CABI SALES CENTER — 331 W. 41 ST. STREET  
FLORIDA  
INTERIOR DESIGN FINAL SET (11-3-06)

In response to your Mechanical Review Comments, SEi Companies offers the following:

CABI SALES CENTER - 331 W. 41ST STREET

Drawing Title:  
**MECHANICAL  
FLOOR PLAN**

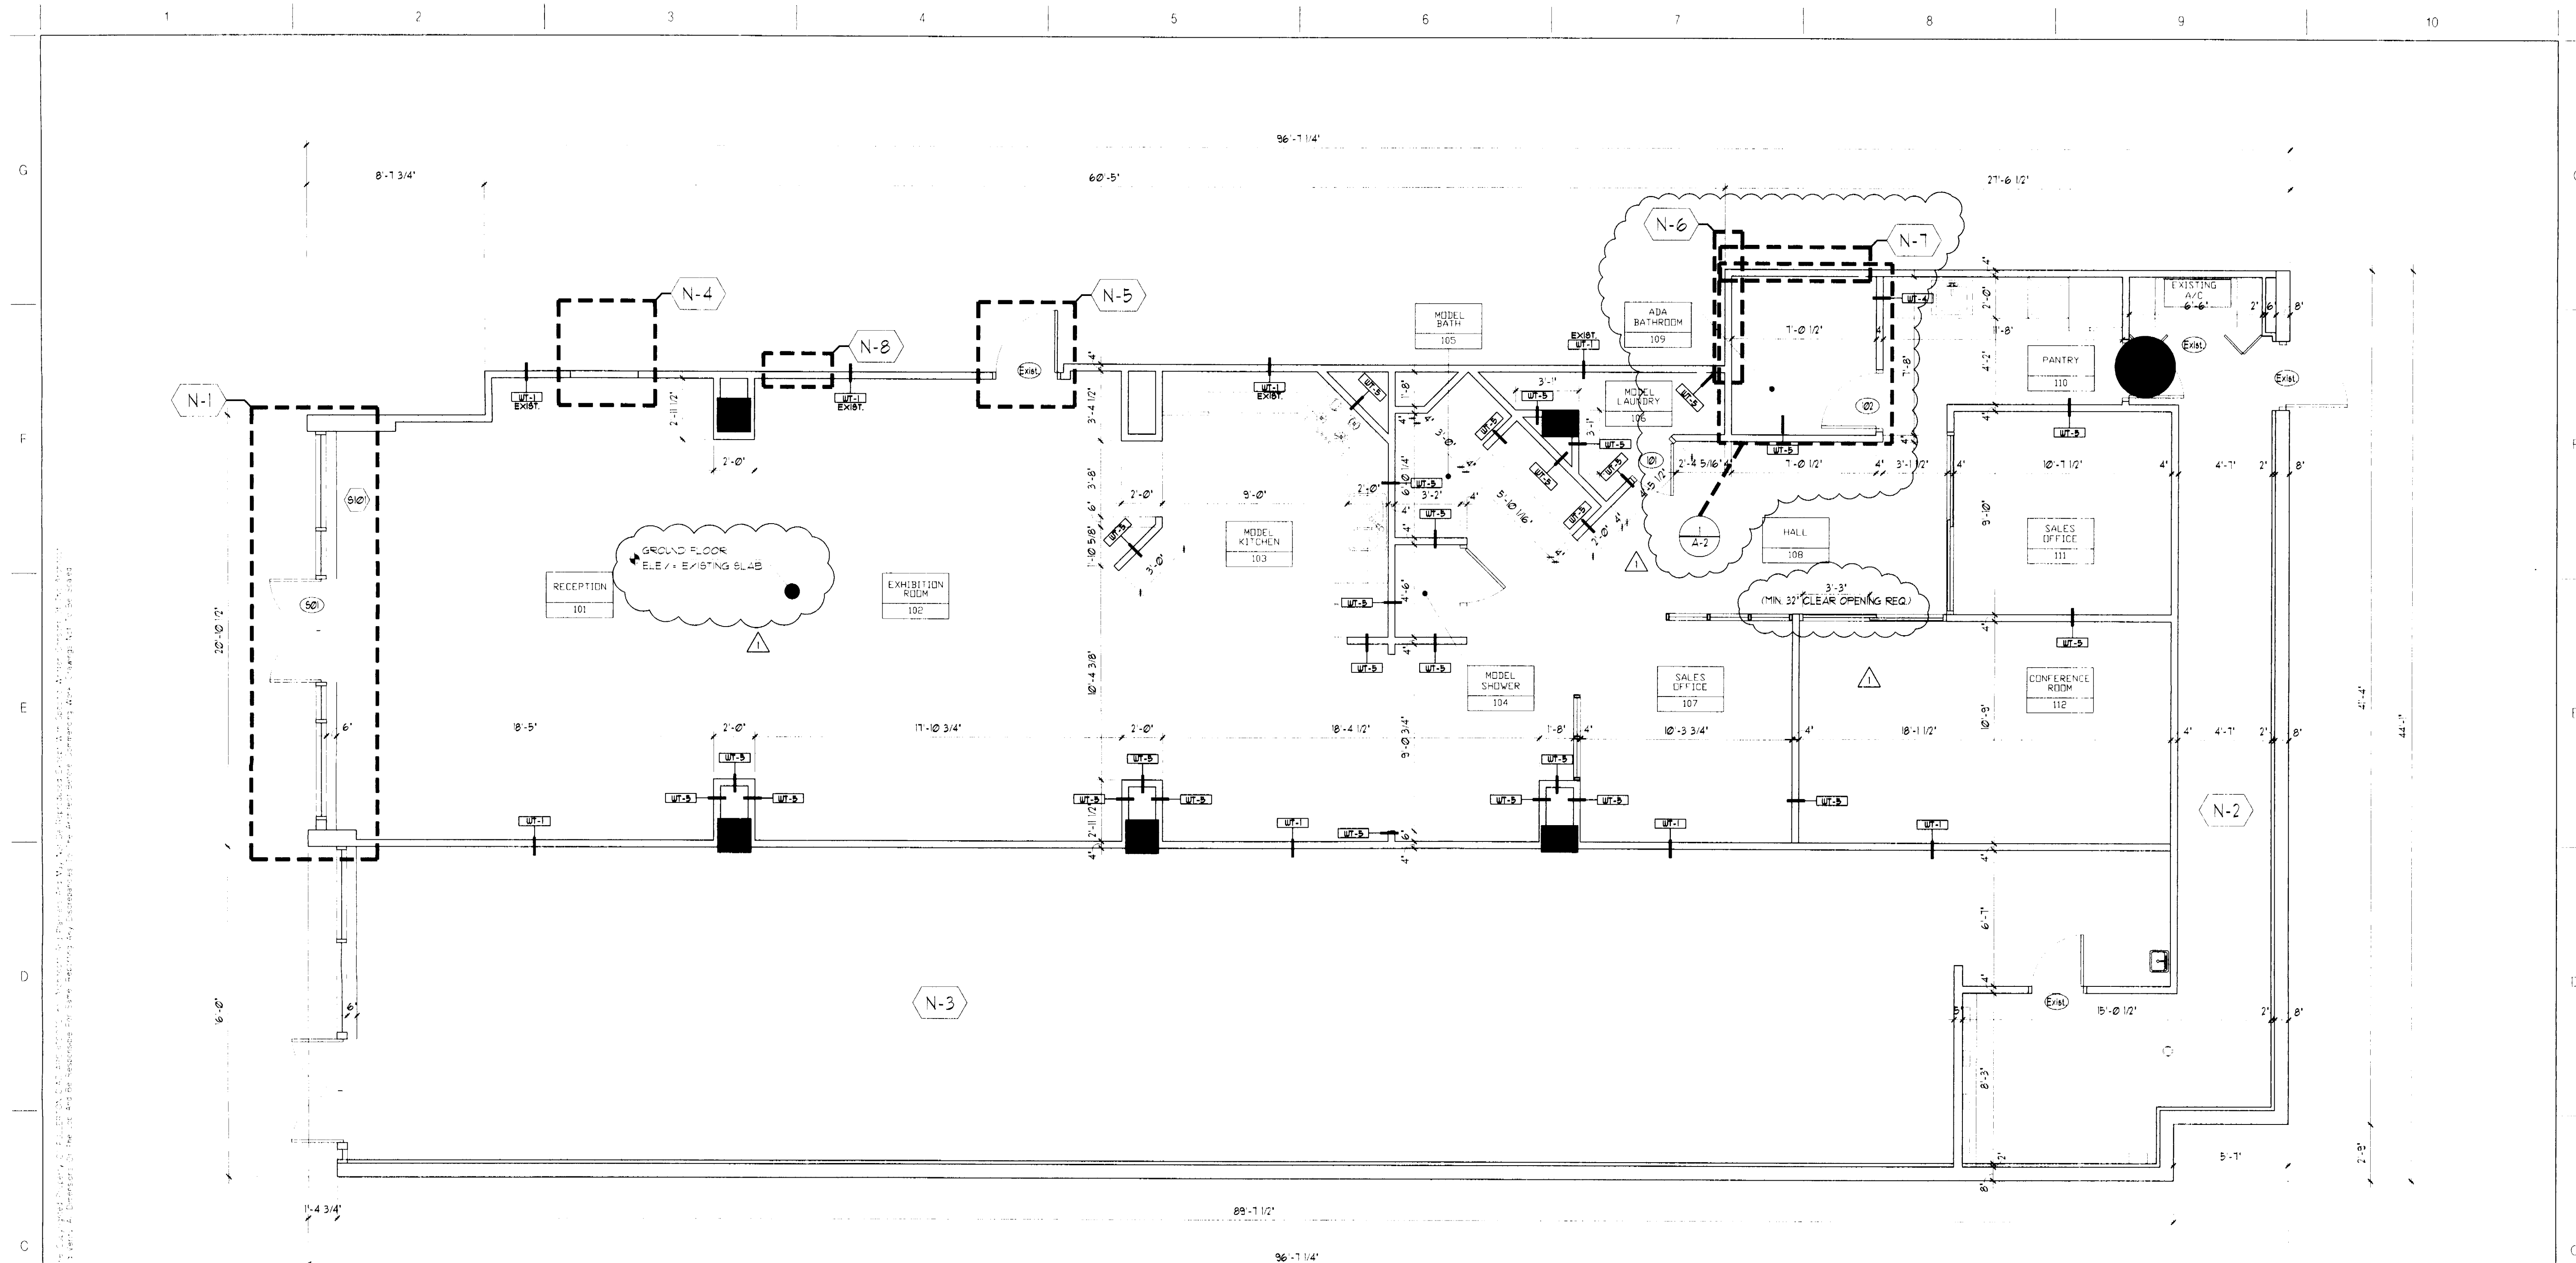
*Comment #1: "New pages show ductwork for two different tenants, provide F/S/D/Protection at the penetration of the rated wall."*

*Comment #2: "Return air from sections of building is showing discharging in corridor need to protect with."*

*Comment #3: "Return air shall be protected with F/S/D."*

*Comment #4: "Mechanical room shall be enclosed in a 1 hour enclosure and ducts shall be protected with F/S/D."*

**Response:** Outside air calculations is shown on the drawing, M0.01. The new ductwork that served the second tenant space has been deleted and removed back to the corridor where fire/smoke dampers would not be required, and capped for future as shown on drawing M2.01.

**Response:** Return air ducts are shown to have fire/smoke dampers at the corridor walls as shown on drawing M2.01.

**Response:** Return air ducts to the mechanical room have fire/smoke dampers as shown on drawing M2.01.

**Response:** Mechanical room now has permanent one hour rated double doors with all of the ducts with fire dampers as shown on drawing M2.01.
